Airworthiness Directives; Eurocopter France Model AS–365N2, AS 365 N3, EC 155B, EC155B1, SA–365N, N1, and SA–366G1 Helicopters

ACTION: Notice of proposed rulemaking (NPRM).

Eurocopter France: Docket No. FAA–2004–18850; Directorate Identifier 2004–SW–19–AD. Revises AD 2004–16–15, Amendment 39–13771.

Figure 1

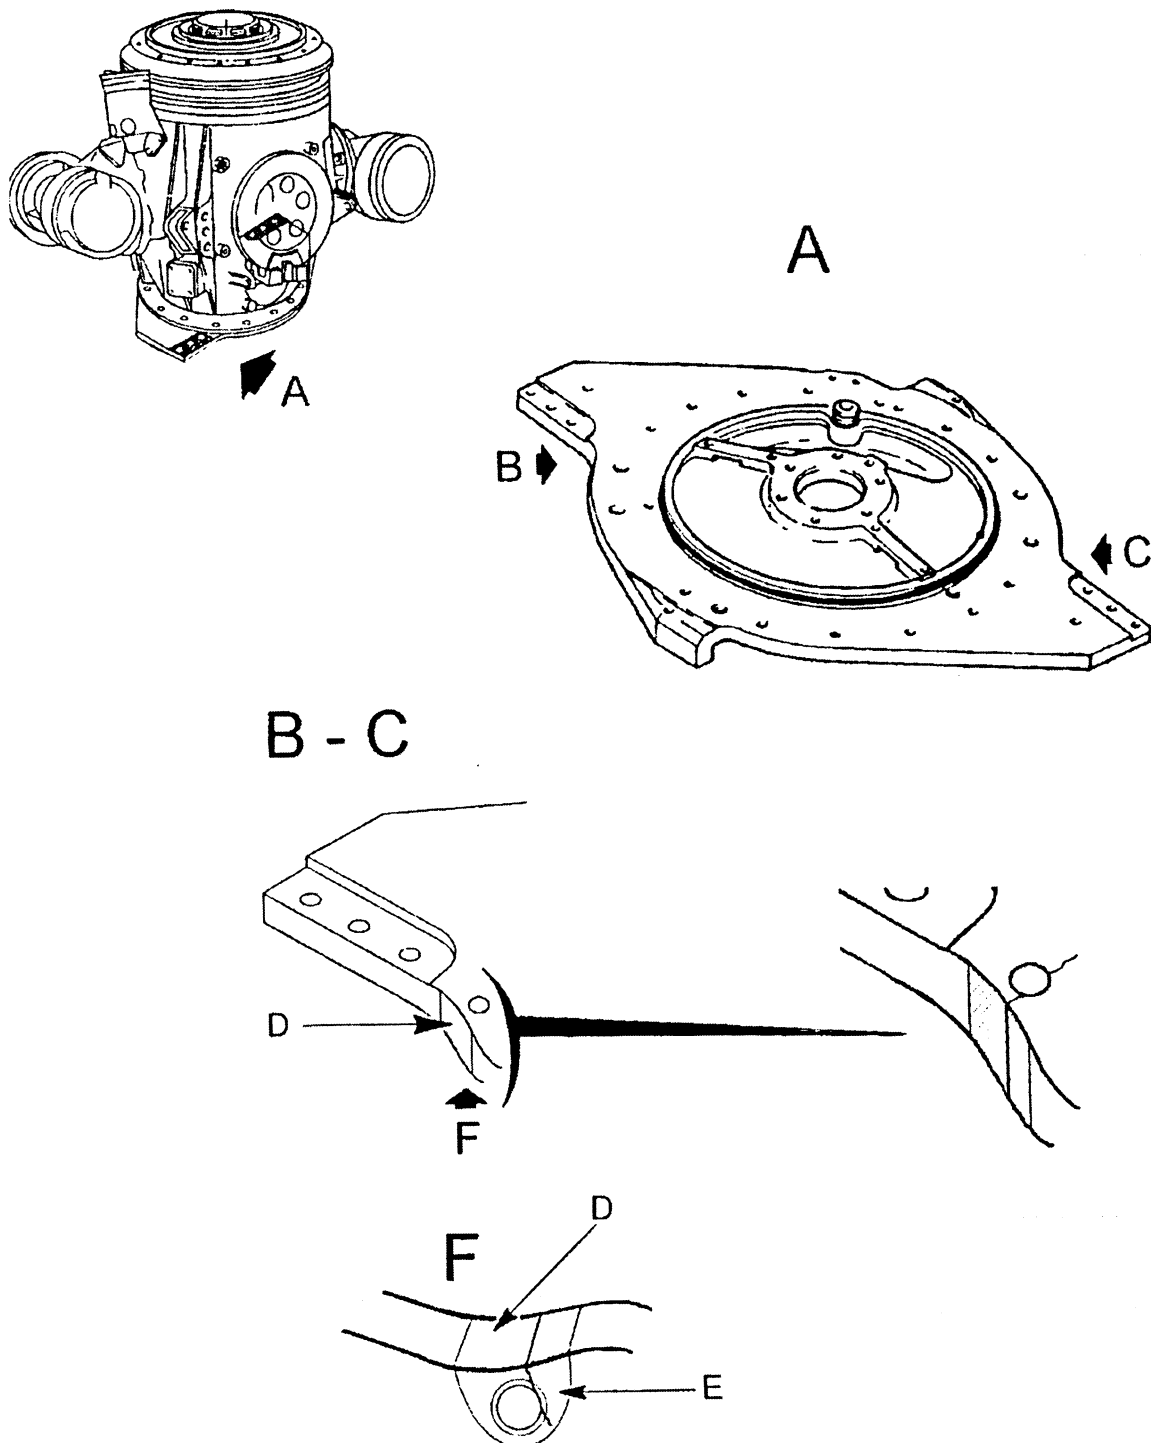
strip the paint from area "D" on both sides ("B" and "C") of the MGB base plate as depicted in Figure 1 of this AD.

(b) At the times indicated in the compliance table, inspect area "D" of the MGB base plate for a crack using a 10x or higher magnifying glass. Area "D" to be inspected is depicted in Figure 1 of this AD.

(c) If a crack is found in a MGB base plate, remove and replace the MGB with an airworthy MGB before further flight.
